LETTER REPORT ON
ADVANCED PLANNING
OF
THJORSA DIVERSION FEATURES

BURFELL PROJECT

PREPARED FOR
THE STATE ELECTRICITY AUTHORITY
GOVERNMENT OF ICELAND
MAY 1963

Subject: Burfell Project
Thjórša Diversion
Features

**DIVERSION STRUCTURES
DIKES AND CANALS
PROFILES AND SECTIONS**

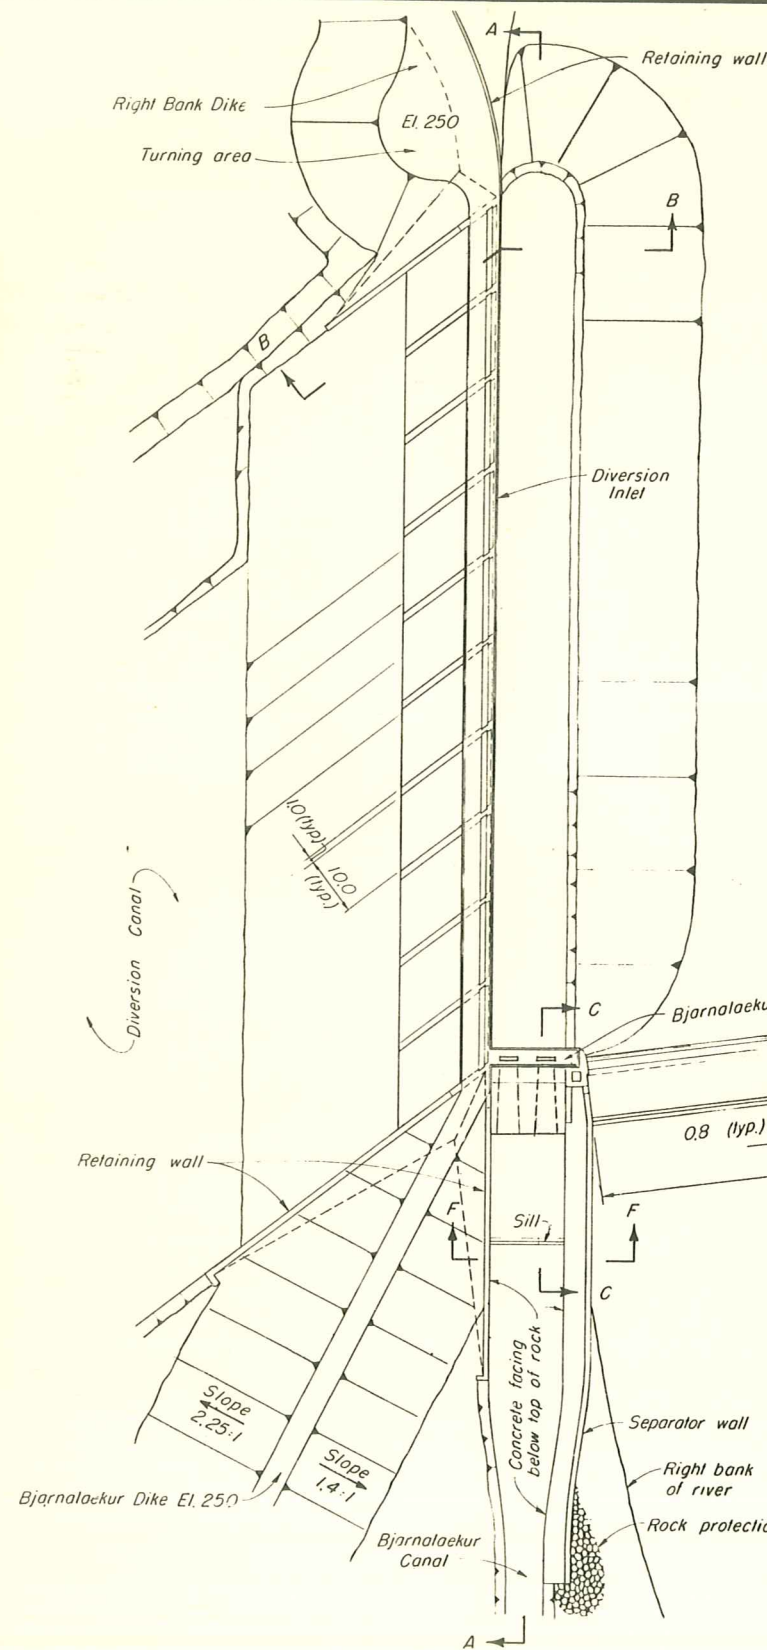
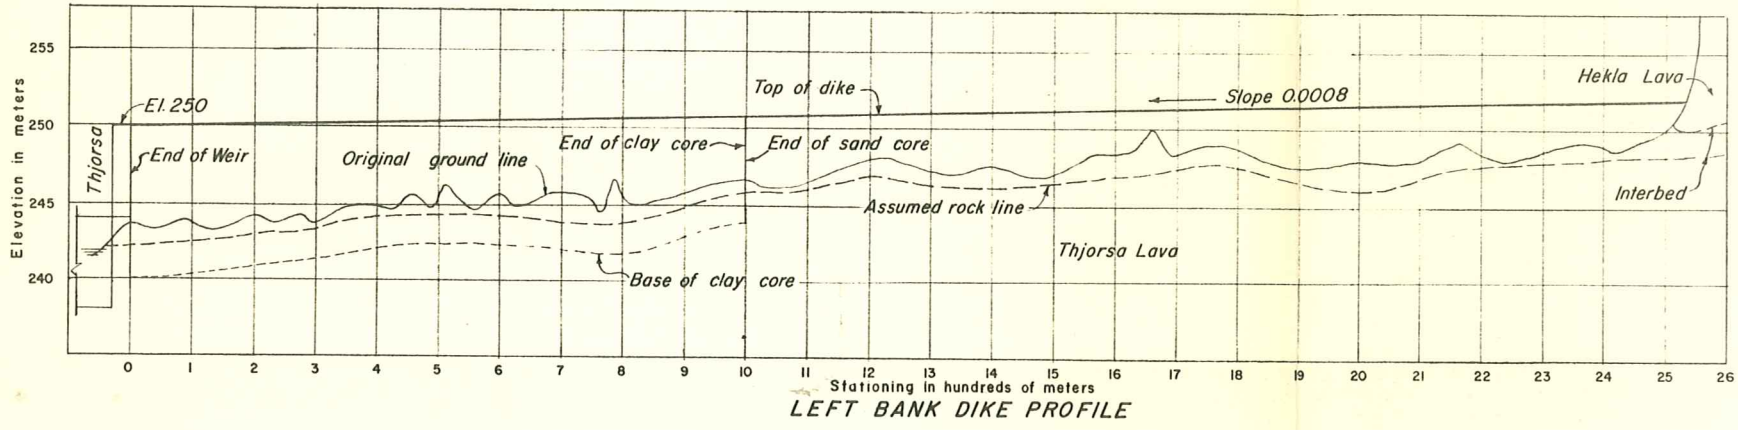
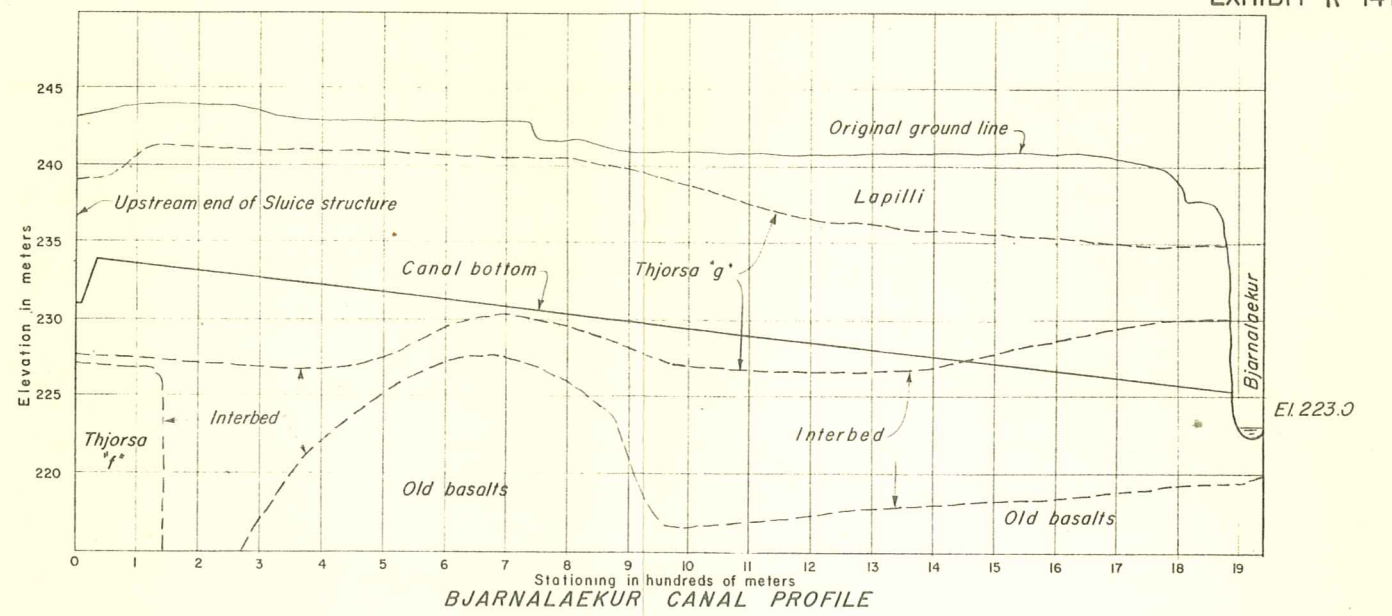
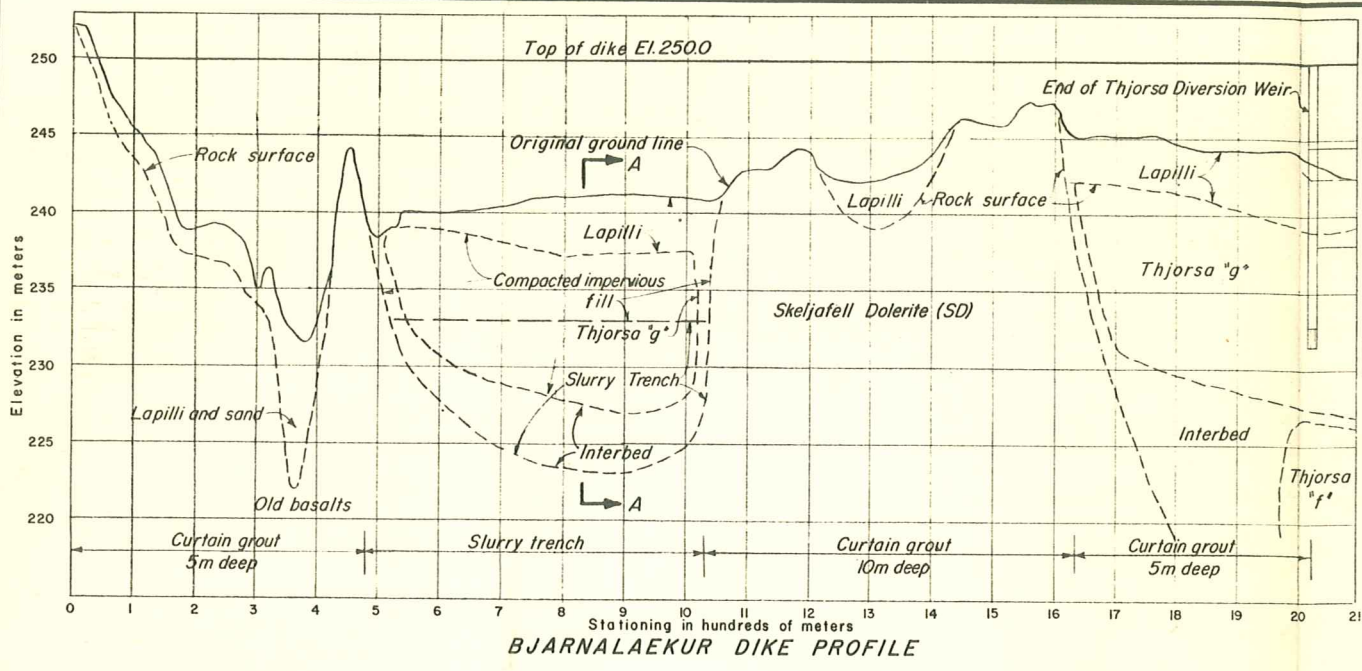
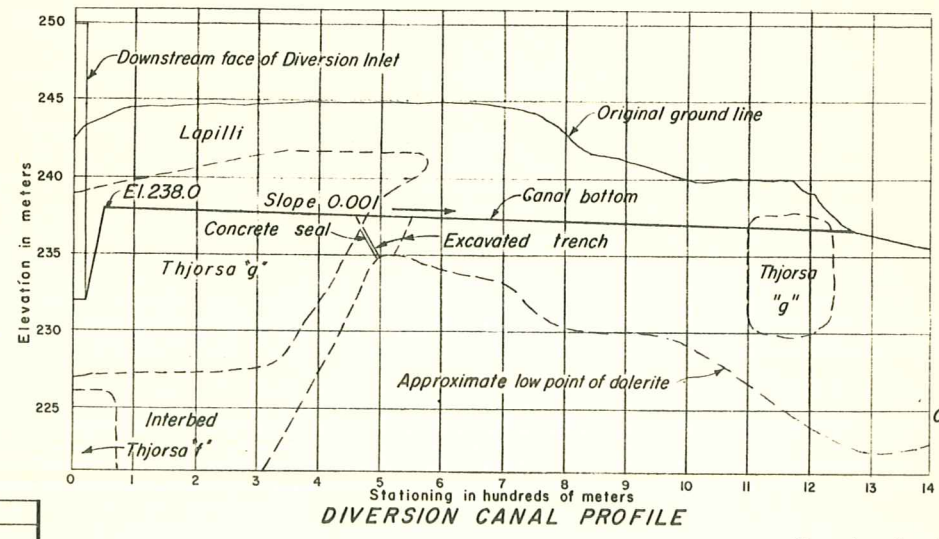
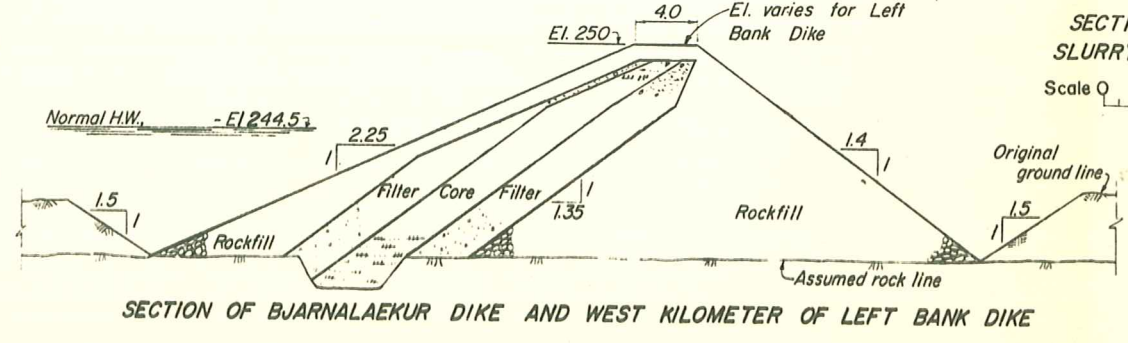
The grade of the Bjarnalækur Canal will cut through the uppermost Thjorsa lava flow and into the underlying interbed as shown by the profile on Exhibit R-14B. This geologic profile was inferred from the several diamond core drill holes along and close to the proposed alignment. A thickness of about five meters of Thjorsa lava below the Canal grade will remain for only about 500 meters from the Sluice Structure. For the next kilometer, the remaining lava will be relatively thin. It is possible that the grade as constructed may penetrate through the lava where a hump of dolerite is inferred to occur about 600 to 700 meters from the Sluice Structure. This will be checked by further drilling.

The section shown on Exhibit R-14B was established to provide a maximum average velocity of about 0.5 meters per second in order to encourage the formation of an ice cover early in each winter season. The Diversion Canal requires a grade at about elevation 238 near the Inlet Structure and a slope of about 0.001. This grade is 5.5 meters above that of the Inlet. Accordingly, it will be necessary that these grades be connected by ramping on about five horizontal to one vertical.

The profile of the centerline of the Diversion Canal is shown on Exhibit R-14B. The geology shown thereon has been inferred from several diamond drill holes, Borro soundings and the geologic mapping. This geologic profile, together with the geologic information included in Volume II of the Planning Report, shows a possible leakage path from the Canal into the permeable lapilli interbed underlying the uppermost lava flow. This interbed will be exposed by excavation entirely across the Canal and beyond on either side at a section about 500 meters downstream from the Diversion Inlet. This interbed will then be covered completely with a concrete seal extending at least as high as the normal water level in the Canal. It will also extend southward, if necessary, to a tie with the core of the Bjarnalækur Dike.

The Dike section was changed to provide a sloping upstream core instead of the central core of the Planning Report section. The revised section is shown on Exhibit R-14B. The selection of this section reduces the requirements for the relatively expensive impervious core. It also permits the use of single filter zones on either side of the core rather than the two zones on either side required for a central core.

The profile of Exhibit R-14B shows the geologic stratigraphy as inferred from several diamond drill holes, Borro soundings, and the geologic mapping. This information, together with general geology included in Volume II of the Planning Report, shows the danger of shortpath leakage from the Bjarnalækur Pond to the Bjarnalækur via the interbed under the uppermost Thjorsa lava flow (THg) for about 500 meters of the westerly one-half of the Dike. In this reach a tongue of Thjorsa lava extends northerly over the unconsolidated materials lying in a valley formed by two ridges of the generally impermeable older basalts.

a mixture of silt, sand, and gravel dumped into the slurry to just above the groundwater table. From this level to the base of the impervious core of the Dike a rolled impervious fill will be placed. A section through this proposed cutoff is shown on Exhibit R-14B. Grouting of the foundations will be required elsewhere under the impervious core of the Bjarnalækur Dike as shown on the profile.

The reasons for the relocation of the Left Bank Dike have been discussed above. The ground surface and rock profiles determined by the March 1963 field investigations are shown on Exhibit R-14B. The selected grade of the top of the Dike is also shown on that profile. The location is shown in plan on the General Project Plan of Exhibit R-14B.

Two dike sections are proposed. The first kilometer of the Dike eastward from the tie to the Diversion Weir will be identical to that of the Bjarnalækur Dike, except for the variable grade. The typical section is shown on Exhibit R-14B. This design will retain the Thjorsa waters to the normal level of elevation 244.5. The remainder of the Dike will be constructed according to the section also shown on Exhibit R-14B. Through this reach water retention, in itself, is not important. It is only necessary to assure that the rare natural diversion overflow waters which may leak through that portion of the Dike do not produce piping velocities. The rockfill under the sand core will be selectively placed for filter effect with fine materials, such as quarry spalls, to the upstream and coarser materials to the downstream.

**DIVERSION STRUCTURES
WEIR AND INLET**

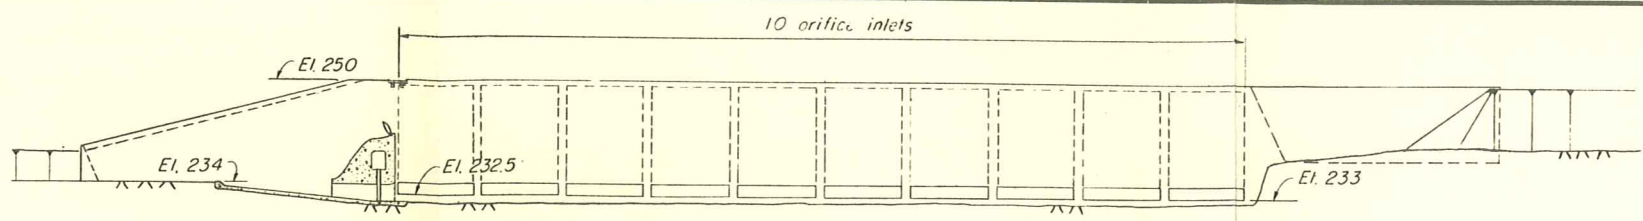
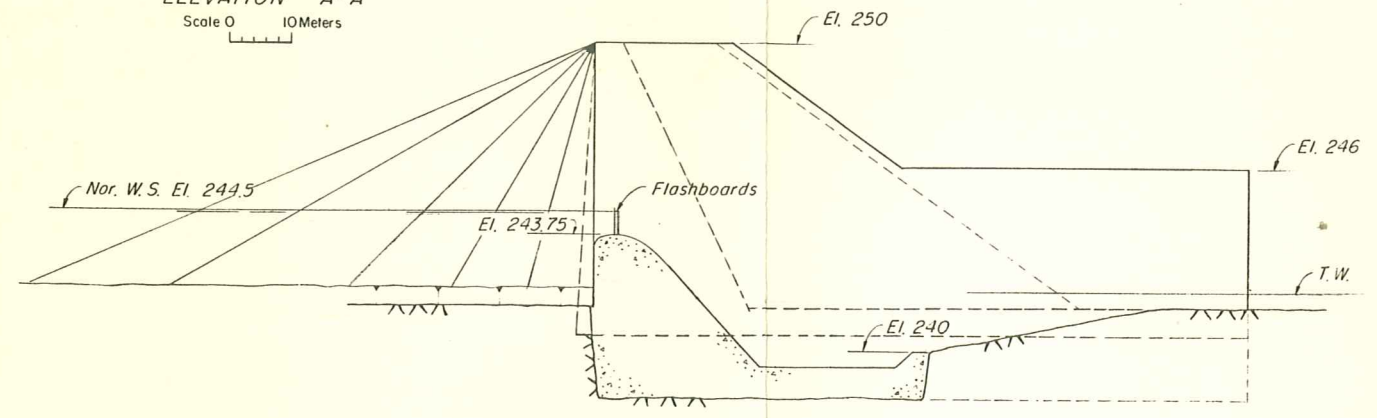
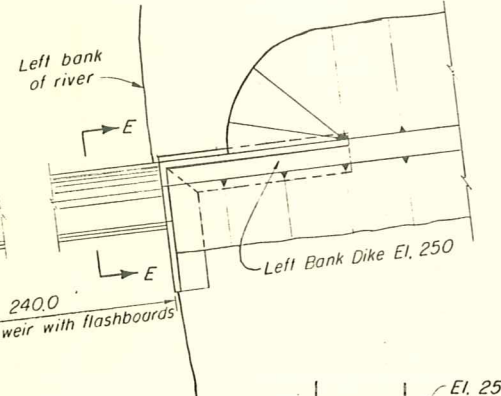
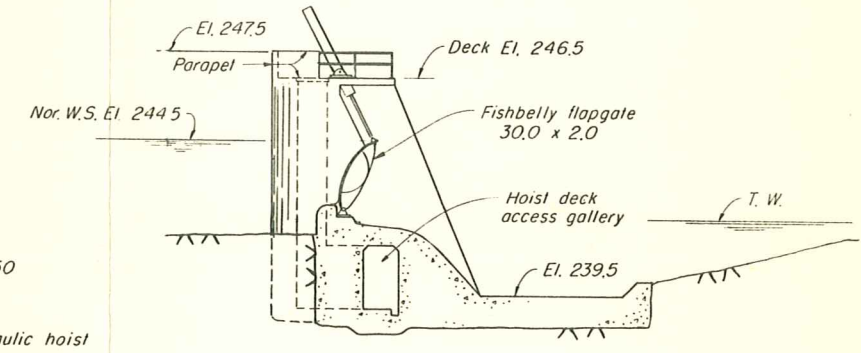
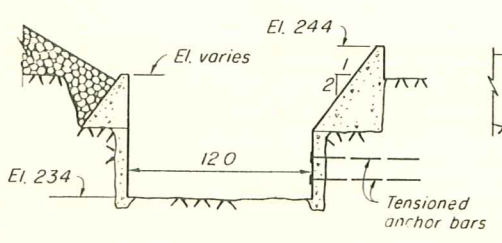
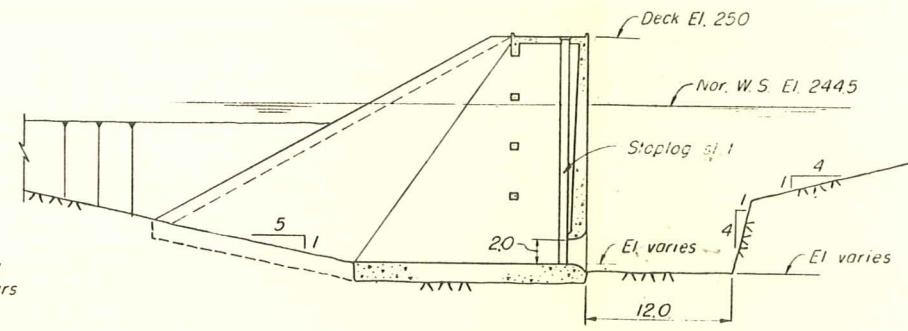
The discharge to the Canal will be controlled by a Sluice Structure representing the right bay of the Thjorsa Diversion Weir. This concrete structure, shown in plan and section on Exhibit R-15, will contain two sluices set at the elevation 231.5 grade, with control provided by two 2.5 meter square wheeled gates. Each gate will be controlled by hydraulic cylinders positioned in a gallery within the concrete mass above. These undersluices will permit desilting from in front of the Diversion Inlet Structure, and also provide water, if required, for aiding in ice and silt transport within the Canal.

The plan and sections of the Diversion Inlet Structure are shown on Exhibit R-15. The basic design of the structure was not changed from that of the Planning Report. The sill of the ports was lowered to elevation 232.5 at the left end and graded upward as before towards the right end. The height of the ports was increased to two meters in order to lower the entrance velocities. The width of the ports normal to the piers was maintained at ten meters each. The bellmouth entrance was shortened to 1.5 meters in order to lessen

possibilities for ice clogging. The face parallels the alignment of the Bjarnalækur Canal. The piers, however, are skewed 37°-30' from right angles to this alignment in order to parallel the alignment of the Diversion Canal and assure smooth flow conditions entering that Canal. Pier rounding will be asymmetrical.

The increase in over-all height of the structure resulting from the lowered grade requires increasing the base width to about 15 meters. Also, the great height of the piers probably means that they will need to be connected by struts. The width of the deck was increased to five meters in order to permit operation of a crane, if required, for silt removal of deposits which might accumulate immediately upstream or downstream of the structure. The deck will be level at elevation 250 instead of sloping slightly upward as in the Planning Report.

The relocated and redesigned Diversion Weir is shown in plan and sections on Exhibit R-15. To the left of the Bjarnalækur Sluice Structure it will consist of two segments. The right segment, 122.4 meters long, will be a gated section; the left segment, 240 meters long, will be an overflow section surmounted by flashboards. The left pier of the overflow section will extend downstream as a training wall and also serve to retain the Left Bank Dike. Beyond the pier a concrete gravity wall will extend for 30 meters to provide a tie to the Left Bank Dike core.

The crest of the gated section was set at elevation 242.5, or only slightly above the existing riverbed. Crest control will be by four

thirty-meter wide by two-meter high fishbelly flapgates. These overflow type gates will permit passing ice with a minimum of water loss. Operation of each gate will be by a single hydraulic hoist at one end. Thus only three piers must be wide enough to accommodate the hoists. One of these will be the left pier of the Bjarnalækur Sluiceway Structure. Two relatively narrow intermediate piers will be required for the installation of sideseals and heating elements.

GRAPHIC CORE LOGS
SHEET 8 of 10

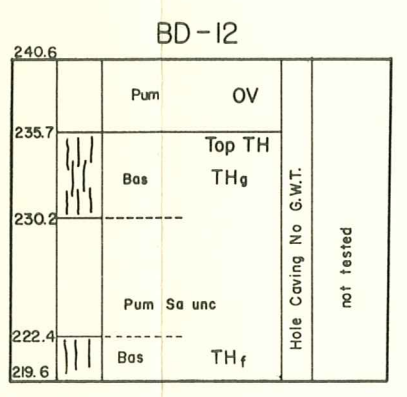
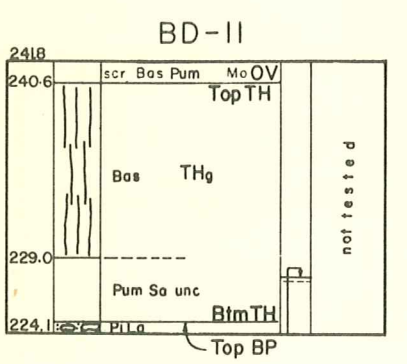
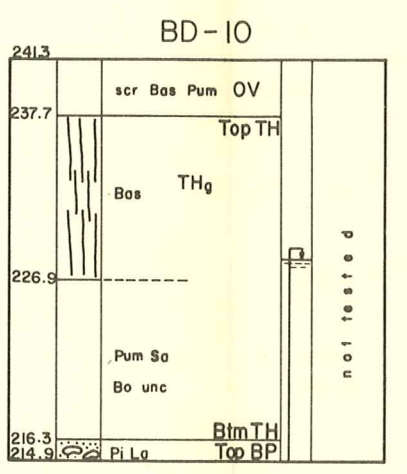
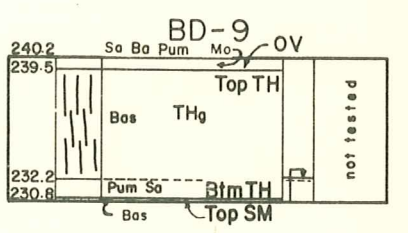
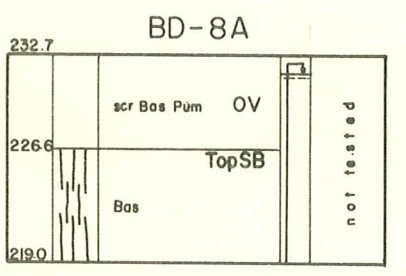
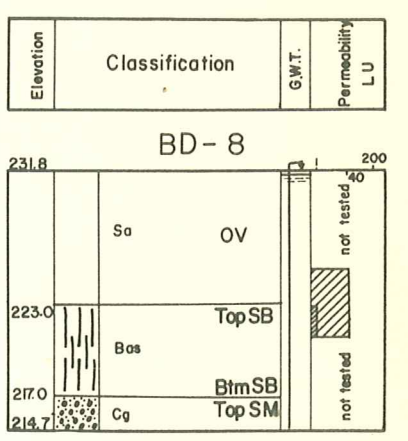
REV. NO.	DATE	NATURE OF REVISION	BY	CHKD.	APPD.
1	4/763	Added BD-12. Corr. BD-4	RH.	GZD	BSL
